AFRICAN DESTINATIONS NEW OFFICE INTERIORS

RENDER DOCUMENT

Rev 3
04 11 2024

BY ACO.\RCH

OSAMAS OFFICE

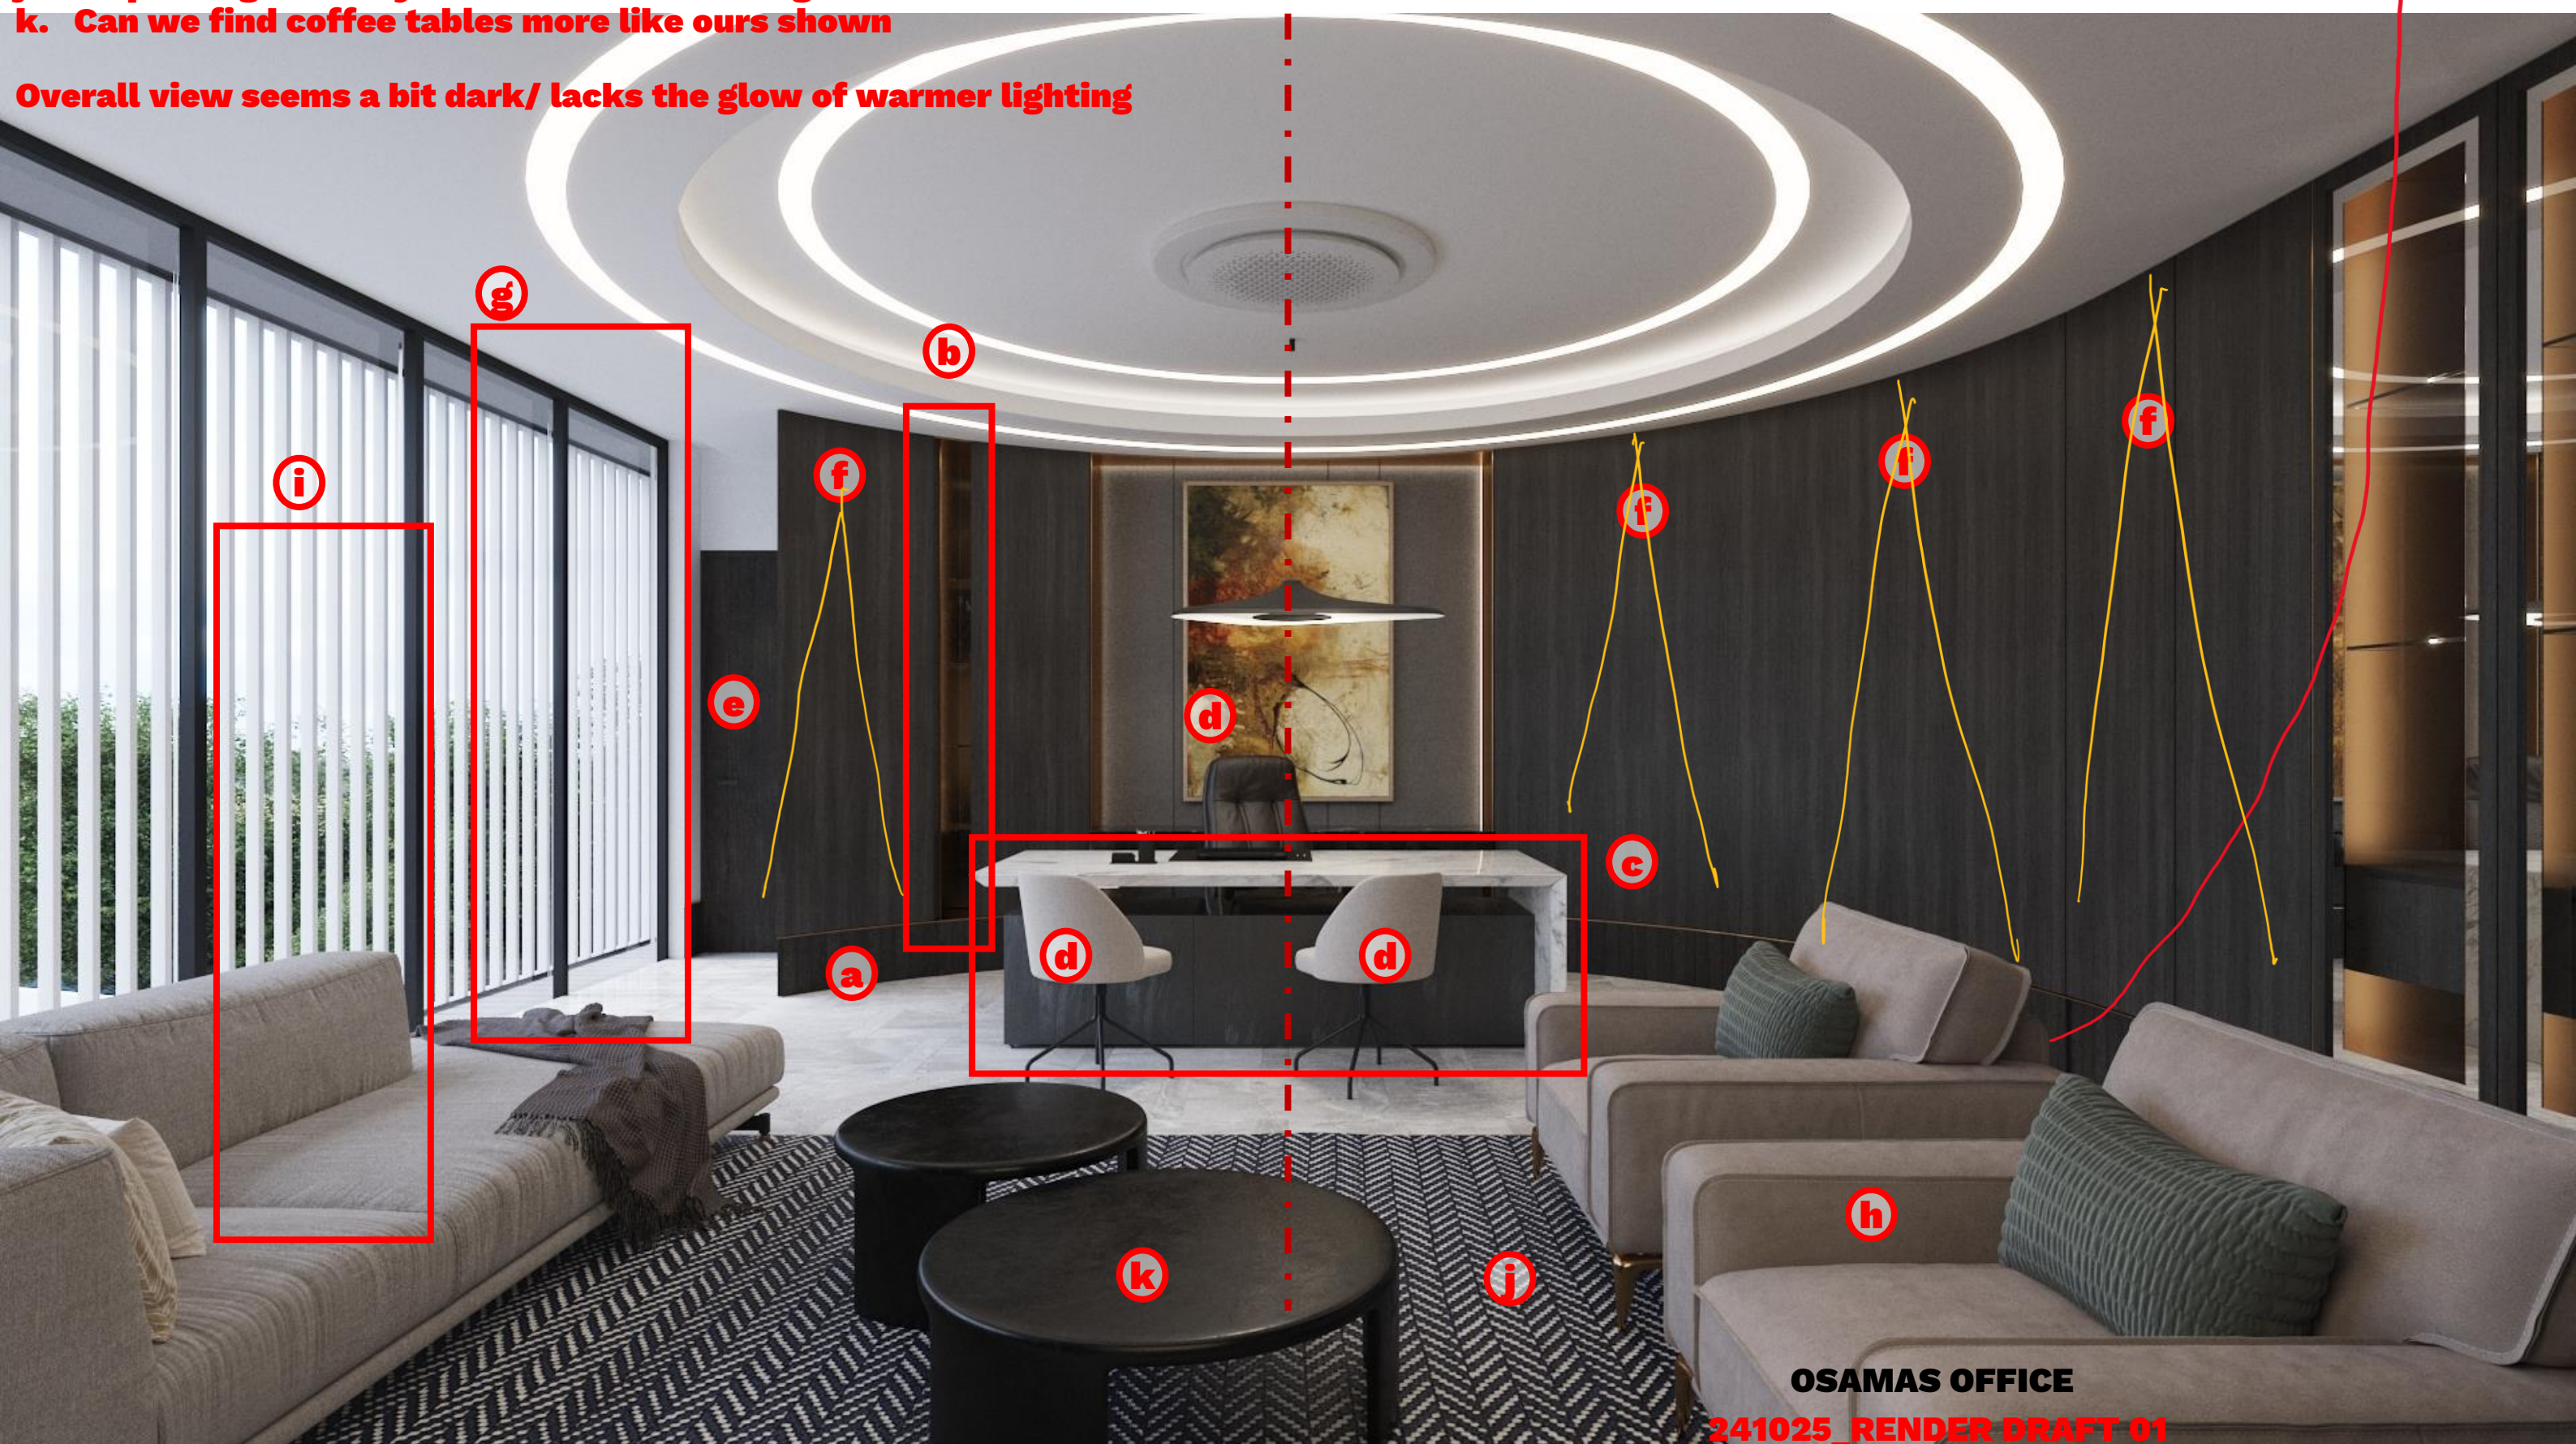
- a. Timber fluted skirting is very dark- Texture and map incorrect – see 01 on previous slide
- b. Light up shelving unit more
- c. Desk incorrect- no return to floor. Desk FBX model sent in email
- d. Center chairs and desk to room.
- e. Make Door white
- f. Add cone lights/ spot lights shining down on casework
- g. Add a curtain
- h. Less chunky arm chairs
- i. Add lamp like our view
- j. Map to rug too busy- could it be something similar to ours
- k. Can we find coffee tables more like ours shown

Overall view seems a bit dark/ lacks the glow of warmer lighting

OSAMAS OFFICE

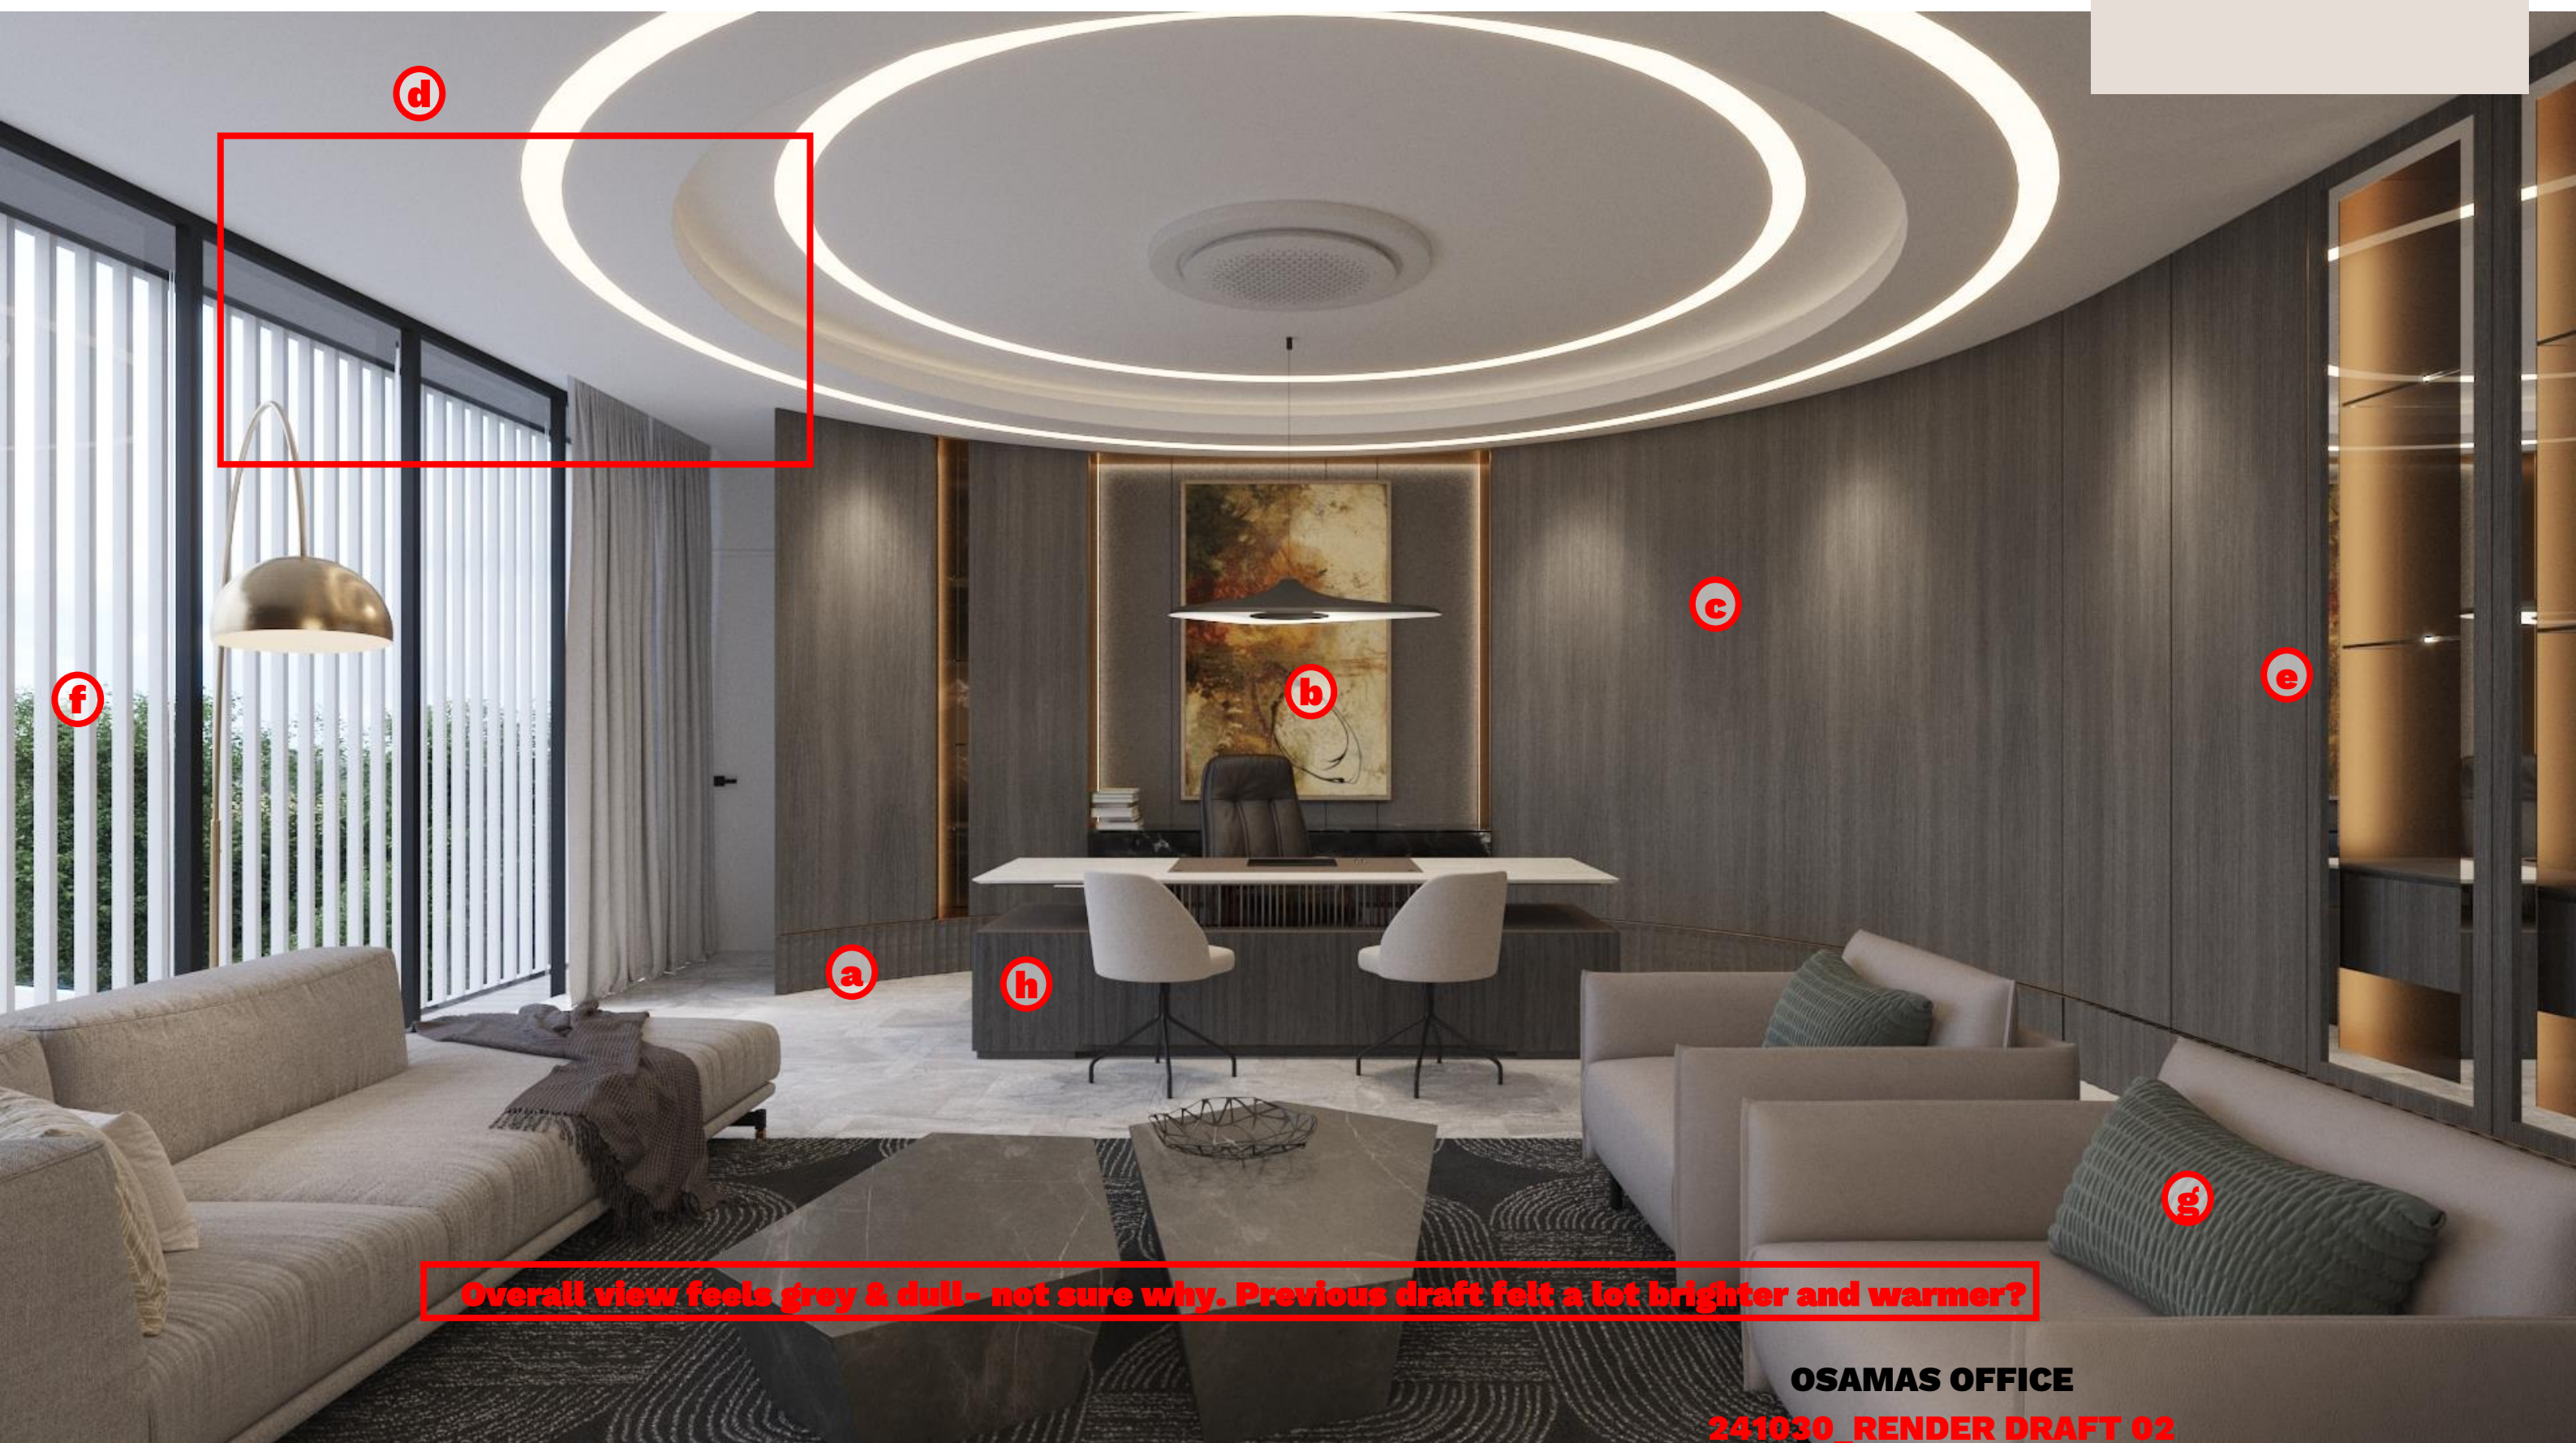
- a. Timber fluted skirting is now a little too light- scale map by 50%
- b. Artwork Map sent
- c. Updated casework and colour map sent (map not great, hope you have a better one)
- d. Track lights missing- in FBX model with Casework
- e. Glass cabinet doors to have bronze frame
- f. External screen to be dark aluminum
- g. Swop out -Match our couches- FBX sent
- h. Timber has gone a touch grey

Overall view feels grey & dull- not sure why. Previous draft felt a lot brighter and warmer?

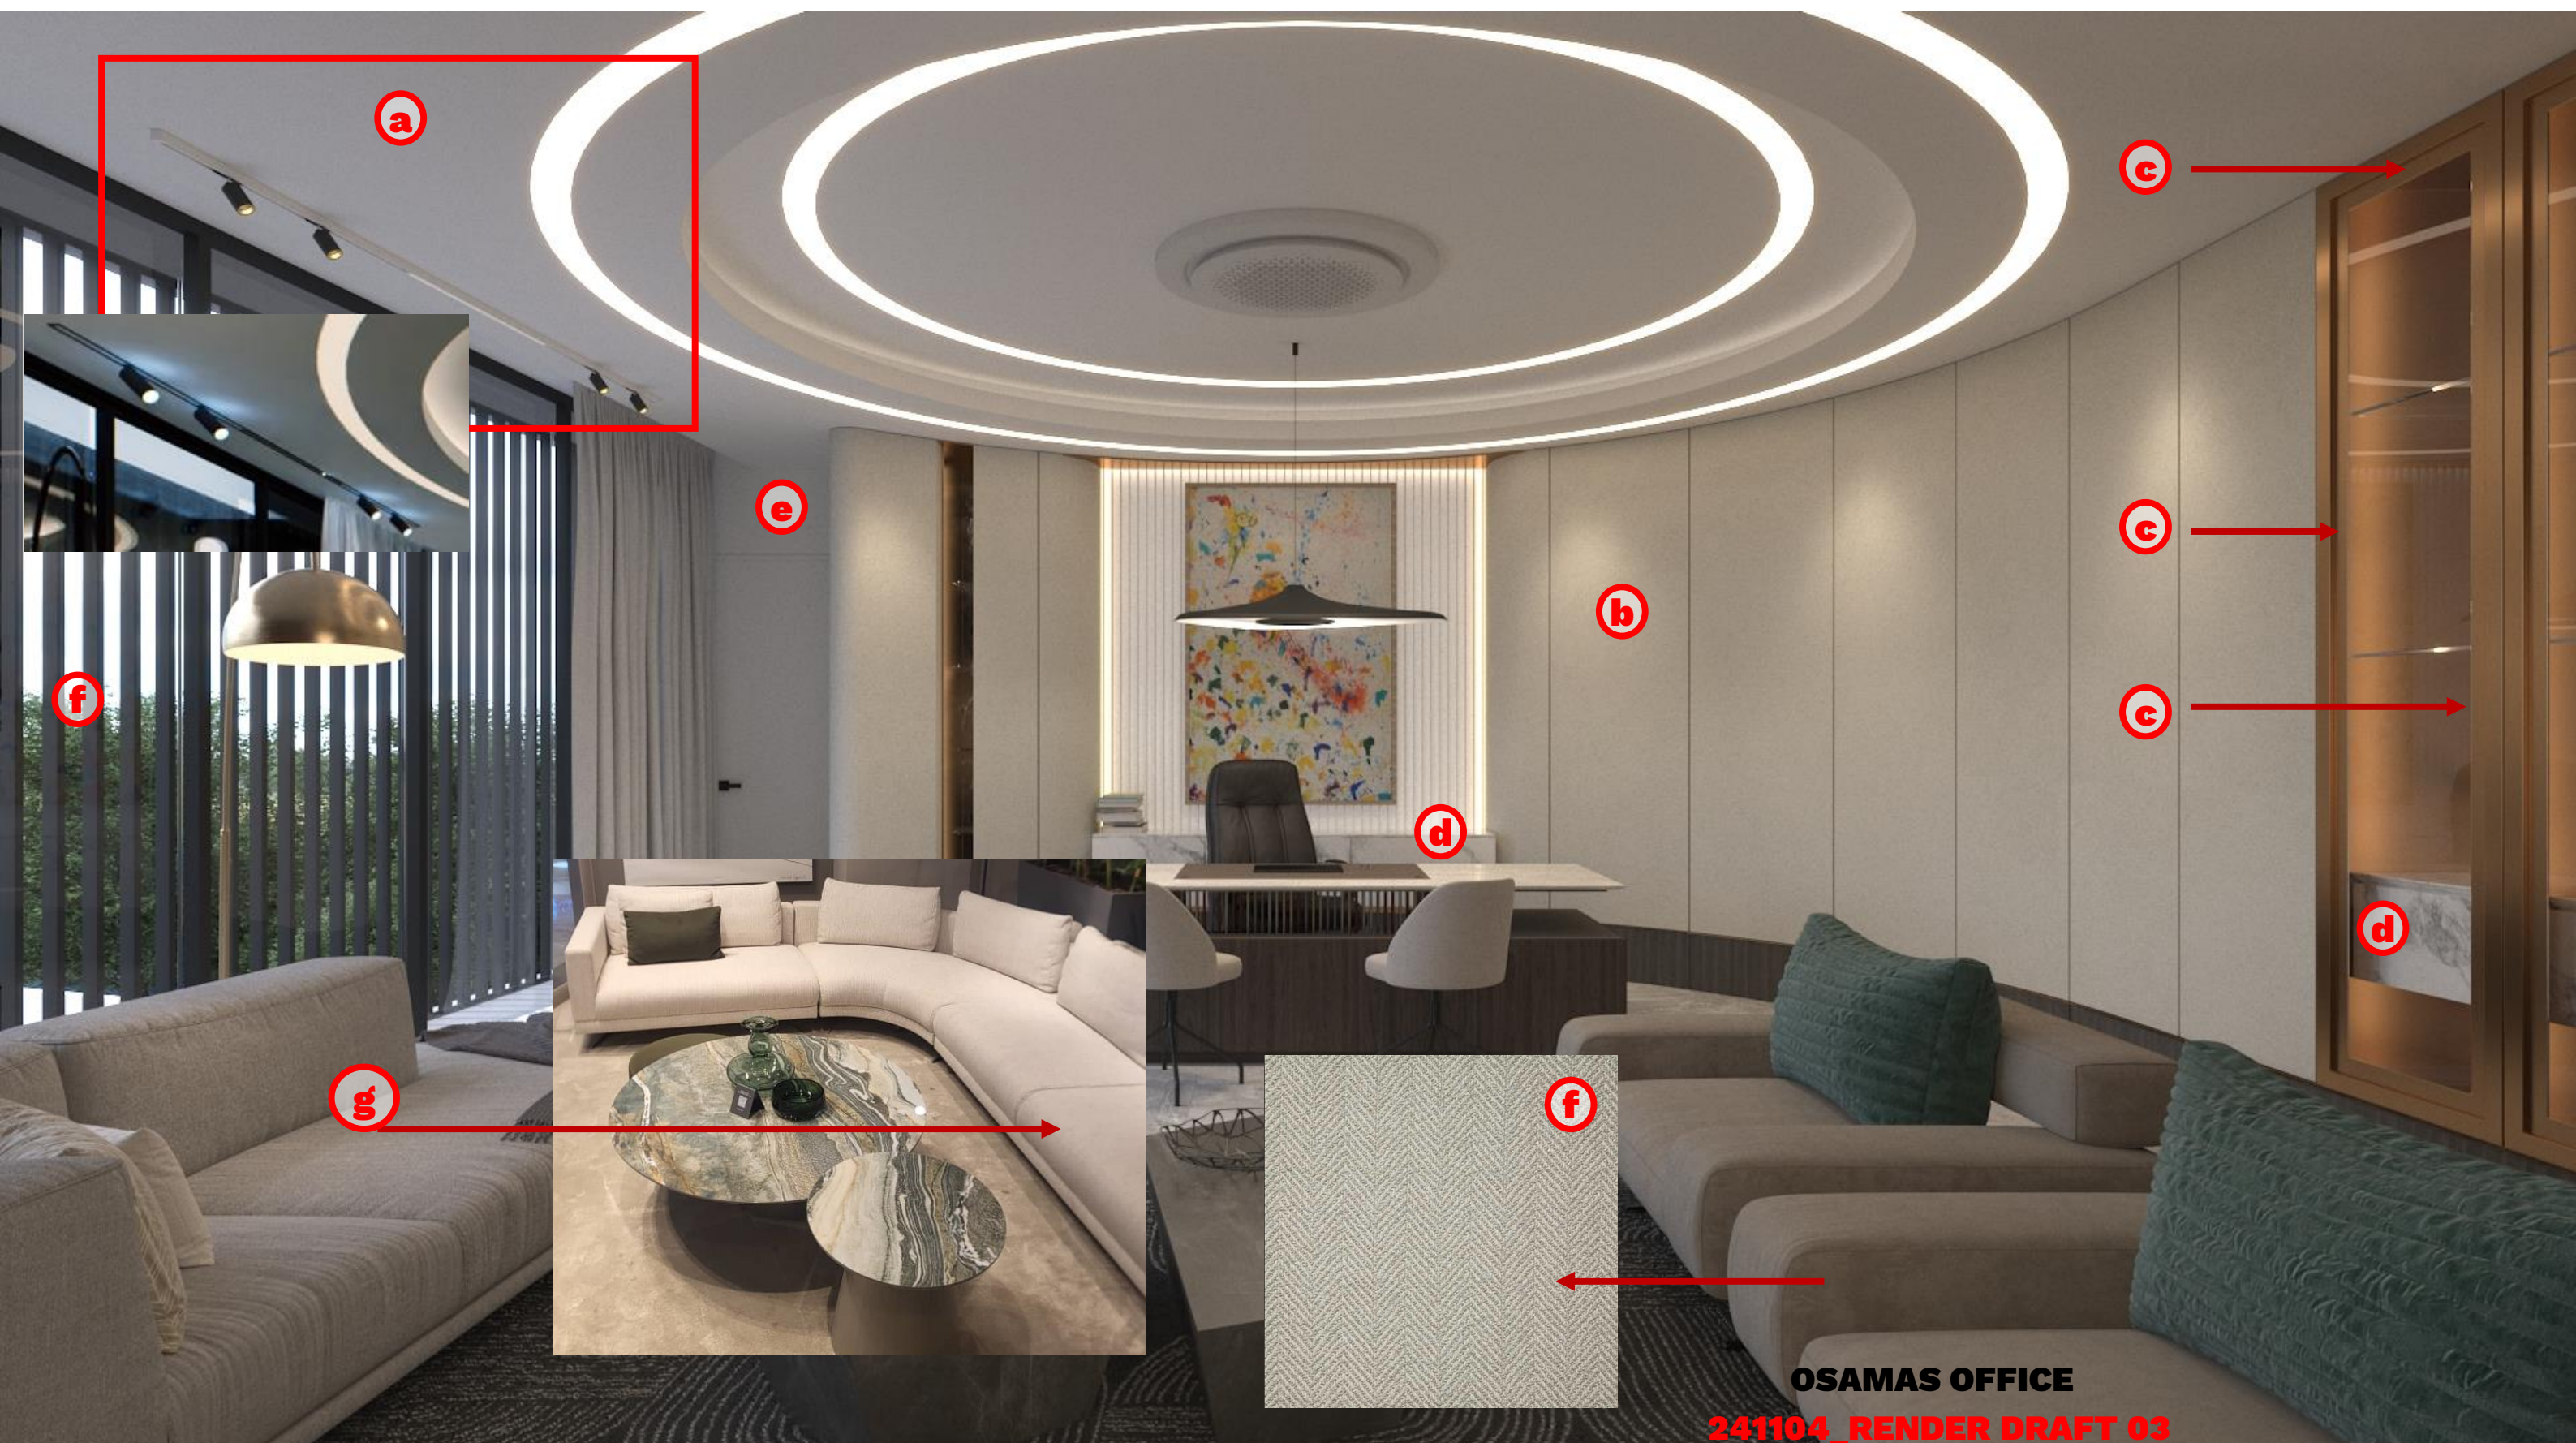
- a. Track light to be black- recessed into ceiling**
- b. Casework Map to be a Matt Sheen – not rough. It will be something like a Duco Finish**
- c. Glass Cabinet ‘inner frame’ to be mirror texture like previously**
- d. Drawer units to be a lighter grey marble- not white.**
- e. Wall & door- same colour as casework**
- f. For the Arm Chairs – can we have a creamy off white material with a subtle pattern. The Map in the 3D asset folder we sent is nice**
- g. Couch also a touch too grey. The client sent us this image on the weekend. He likes these light softer colours.**

Casework Map to be a Matt Sheen – not rough – like a Duco Finish
